Re: PLANNING APPLICATION NO DM/14/01268/RM

Reserved matters application in regard to northern access road pursuant to planning permission CMA/4/83 (Mount Oswald), by Banks Property Development Ltd.

At the side road leading north towards the proposed student accommodation the junction detail is shown as follows:

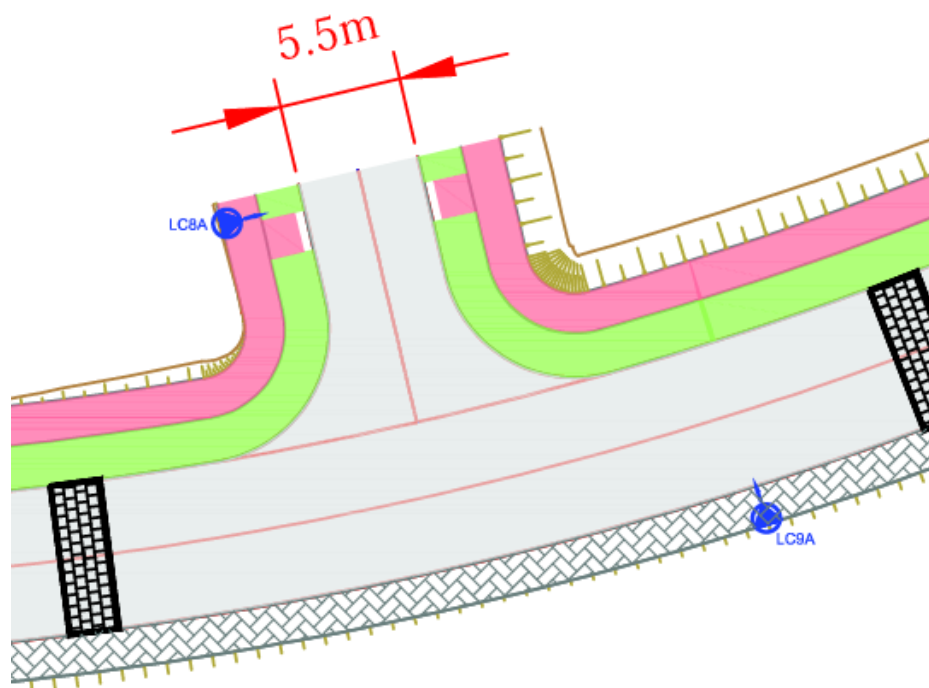
People walking along the footway shown in pink will have to deviate considerably from the desire line across the mouth of the side road. The route should be as near as possible in a straight line. If the crossing has to be set back for some reason, the approaches should head towards it gradually with the grass verge widening.

Tightening the corner radii will reduce speeds of motorists using the junction and thereby make pedestrians safer. The radii shown in the diagram are between 5 and 6 metres. A tight radius of as little as 1m is recommended by sustainable transport consultants (e.g. Phil Jones Associates, Cycle Infrastructure Design training course). There should preferably be some form of junction treatment such as a raised table. Indeed, more progressive councils are designing side roads so that the pavement goes straight across, giving a strong visual indication to the motorist that pedestrians have the right of way. A level pavement across the junction particularly benefits parents with buggies and users of wheelchairs and mobility scooters.

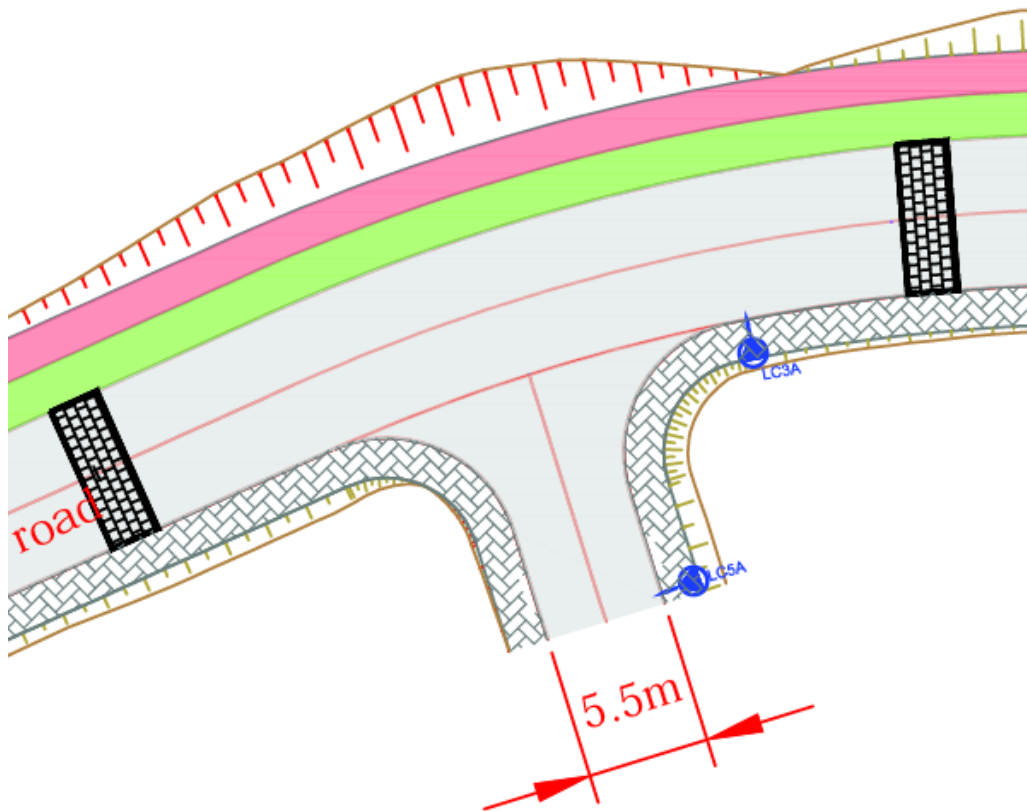
The other junctions with side roads could do with similar treatment. On the south side the footway is shown paved with blocking and next to the carriageway, but again corner radii should be tightened and a level surface for pedestrians could be provided. This sort of feature helps to

The junction pictured above leads to the medical centre and a car park possibly for the offices pictured alongside. The verge is shown continuous on the north side, but there should be breaks in the grass verge to provide for pedestrians to reach the kerb to cross the road on each side of the junction.

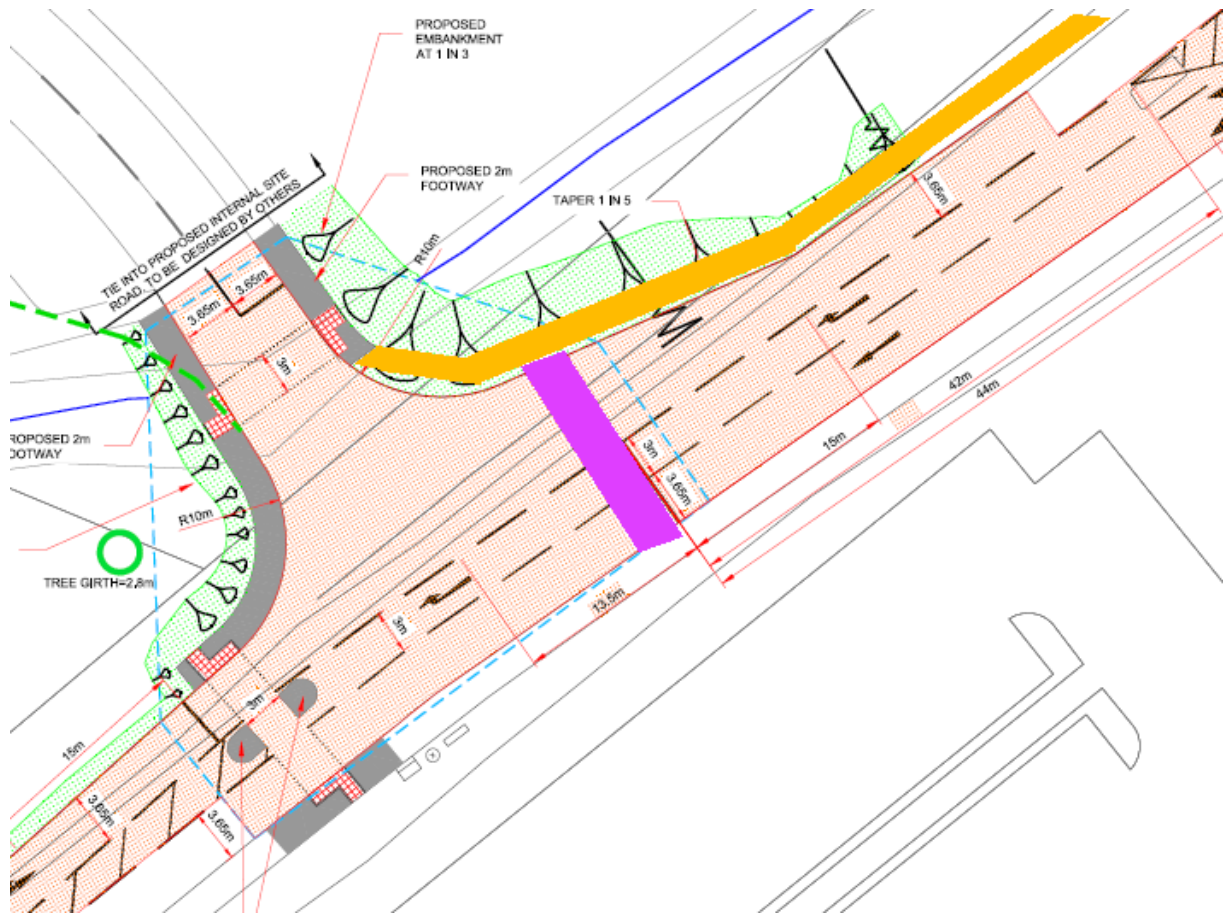
At the junction with the A177 the facilities proposed for pedestrians are very poor. Pedestrians walking along the north side of the access road (for example those walking from the student accommodation) would have to first cross the access road at the lights, go round the corner and cross the A177 before turning back towards the University. We understand from the Planning Statement submitted by the developer (paragraph 2.10) that the outline planning permission which established the access point on the A177 had the footway in a different place but this was changed at the request of Highways officers. Was this in consideration of free traffic flow, or of pedestrian convenience, or for some other reason?

Why is there not a third pedestrian crossing? If there can only be two crossings, surely it would be better to omit the A177 crossing that is shown and instead cross the A177 the other side of the access road (added in purple on the excerpt below) where more of the potential users are likely to want to go?

Perhaps the reason no crossing is provided is the 1:5 taper which is probably to help buses turning towards Durham out of the access road. Is this strictly necessary? It may not even be in the right place for buses (see later section). Wide junction mouths are not good for cycling safety either.

The other big omission is that of a pedestrian footway on the north-west side of the A177 heading towards the town centre (added in orange on the excerpt below). There is no footway at present, but surely one should be provided: we have too many roads in Durham with pavements only on one side as it is. There might be a problem extending a footway past Van Mildert College but it should at least be possible to provide one as far as the traffic lights for the Park & Ride, where a pedestrian crossing of the road could be incorporated (this might also obviate the need for three crossings at

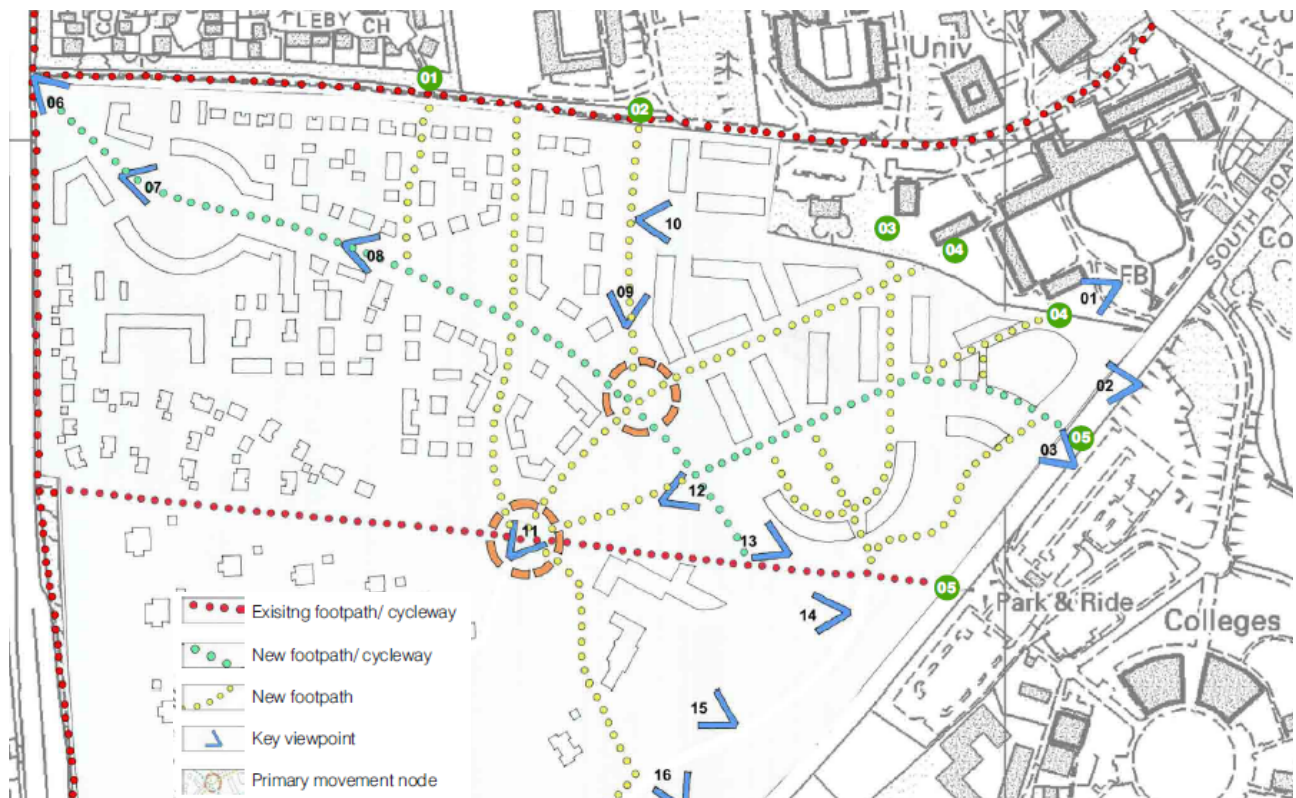
However, the plans shown at the public exhibition prior to the granting of the outline planning permission actually show few routes for cycling. On the excerpt below the blue dotted lines are footpath/cycleway and the green dotted lines are for walking only.

The blue dotted line linking to the A177 on the plan above is actually on the line of the access road that is the object of this planning application. It is noticeable that the following routes likely to be required for cycling are not provided:

- linking the southern neighbourhood to the northern part of the development
- access to the A177 (because cycling provision is not included in the access road)
- links to the Business School, various colleges, the Oriental Museum and onwards to Elvet Hill Road and the route into the city via Prebends Bridge.
- internal links within the estate to encourage cycling: these could be mostly via the roads if they are designed carefully.

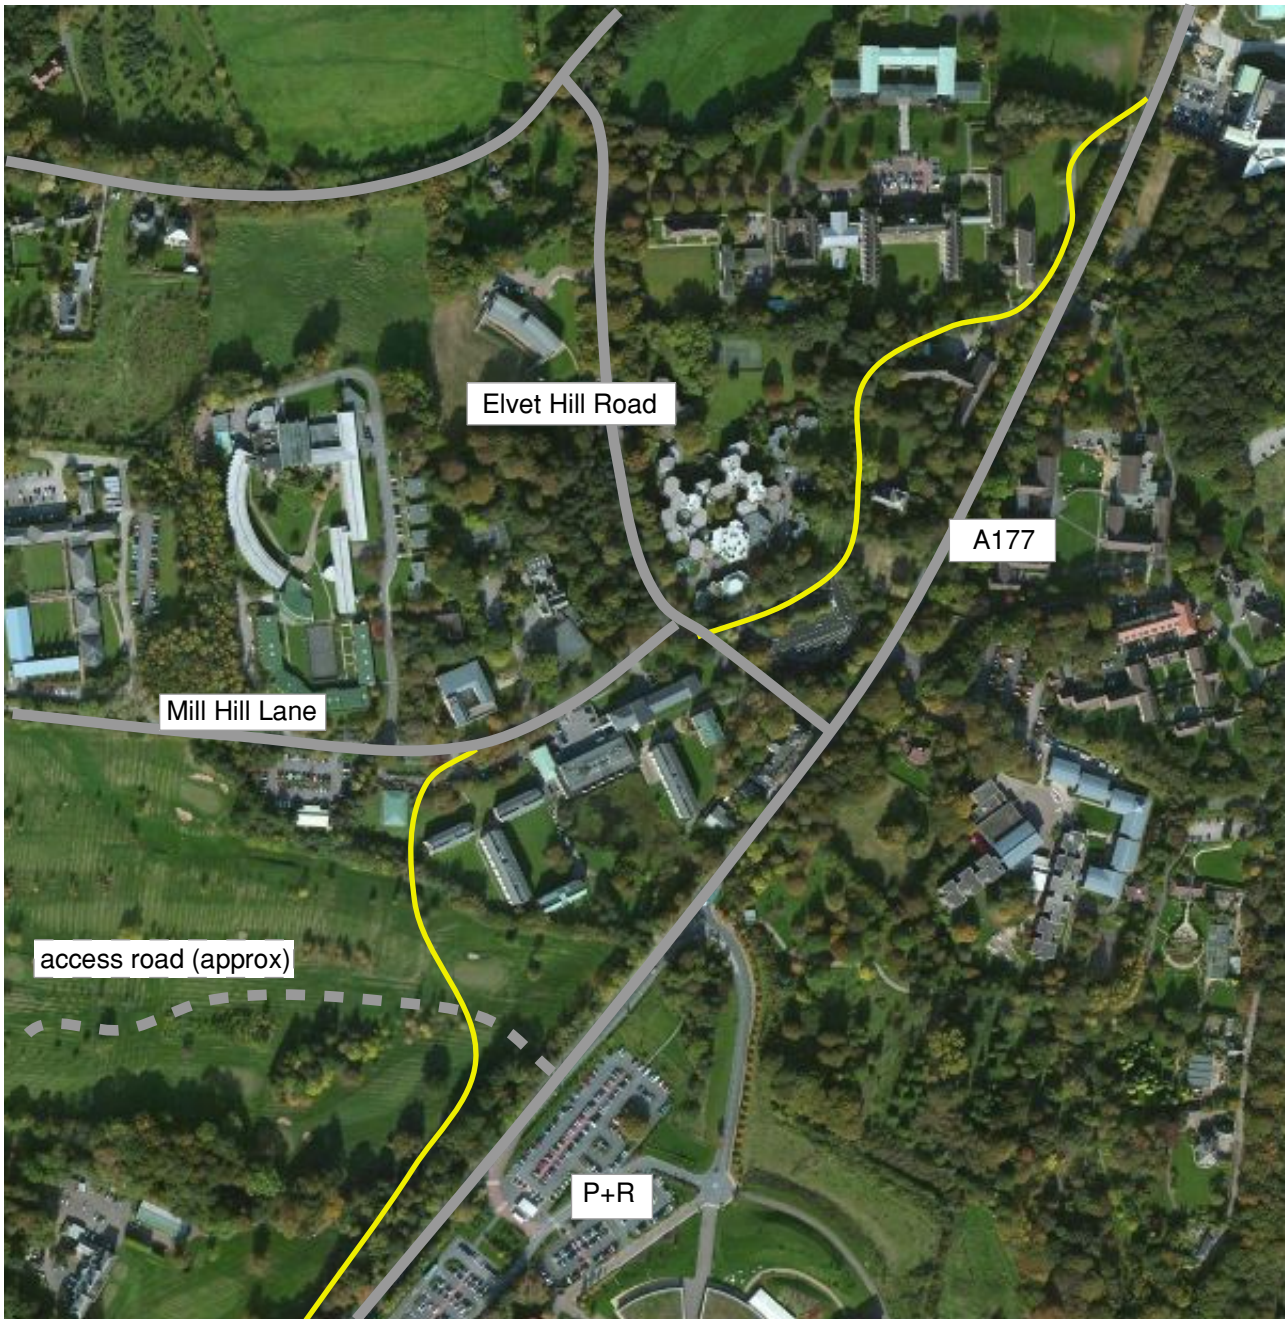
The section from Elvet Hill Road down to the New Inn could be problematic because of the height of the neighbouring land limiting the width available. The pavements are already narrow. An alternative might be to take a route opposite the end of Mill Hill Lane across University land down the side of Trevelyan College and the boundary between St Mary's College and Teikyo University's buildings. There may not be enough space to do this, and the University may be unwilling to see a public route created on this alignment. The route from the south along the A177 would have to connect to Mill Hill Lane close to Van Mildert College to achieve continuity. This option would however also connect nicely with the popular cycling route along the north edge of the Mount Oswald site. The route in yellow on the following satellite view shows one idea for this.

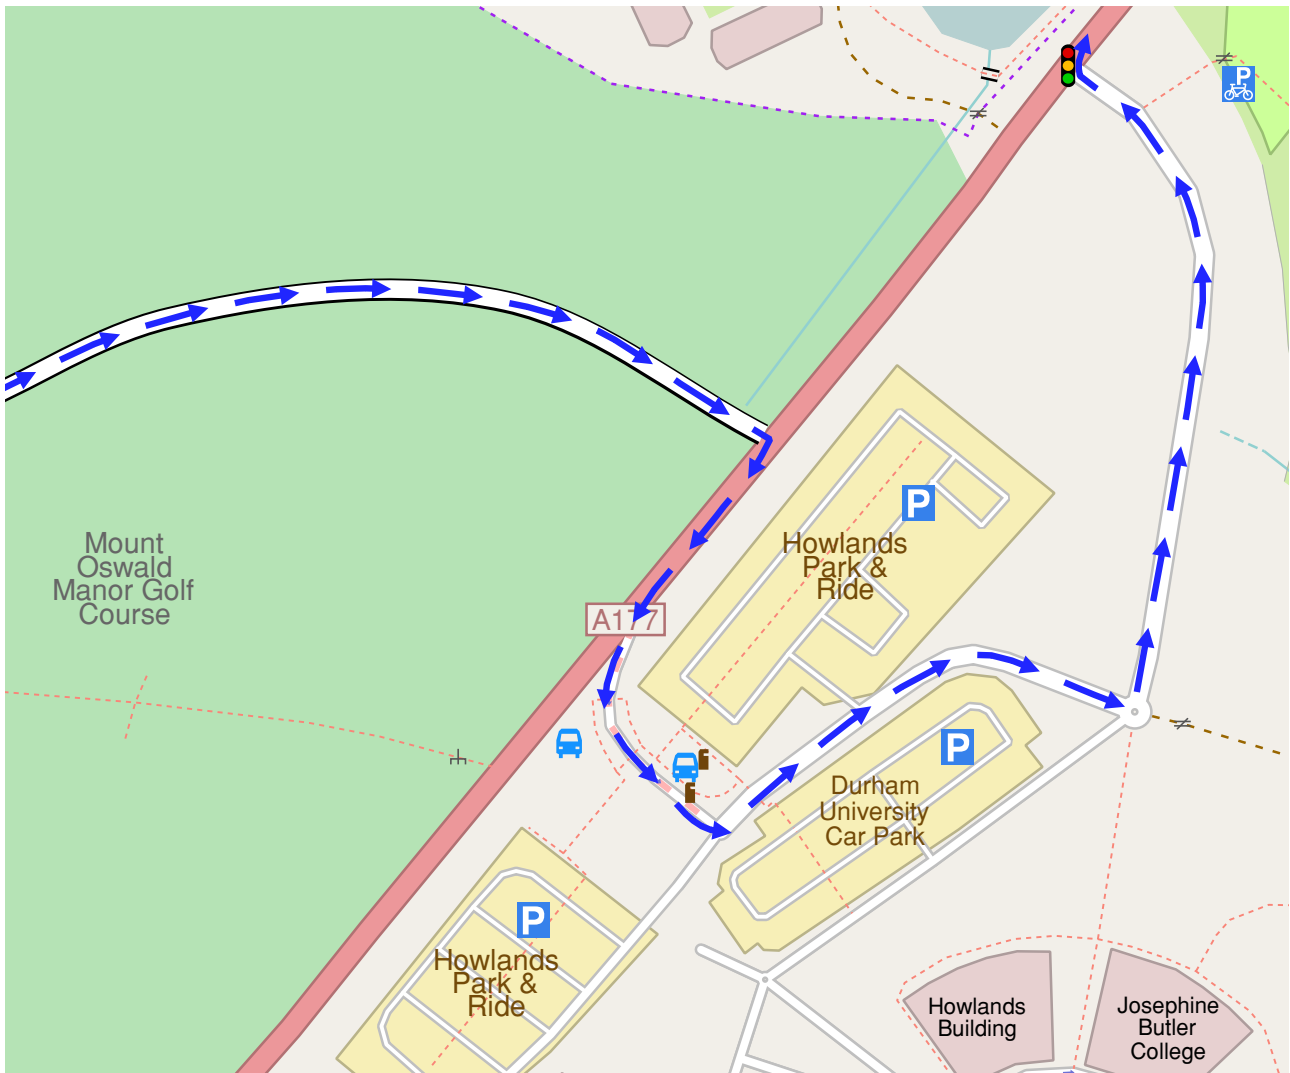
We have already remarked on the 1:5 taper at the access road junction with the A177, and questioned whether this is necessary. If its purpose is to aid buses turning out of the estate, then it may be in the wrong place. The plan proposed for the bus service to the new development involves extending the Park & Ride shuttle bus services which currently serve the Howlands Park & Ride site. It would be undesirable for the buses to pick up passengers at the Park & Ride car park and then to drive into the Mount Oswald estate, as this would delay users of the Park & Ride from getting into town. The bus will surely be picking up in the Mount Oswald estate before picking up at Howlands. The route would therefore be as shown below:

Thus the buses would be turning right out of the access road, not left.
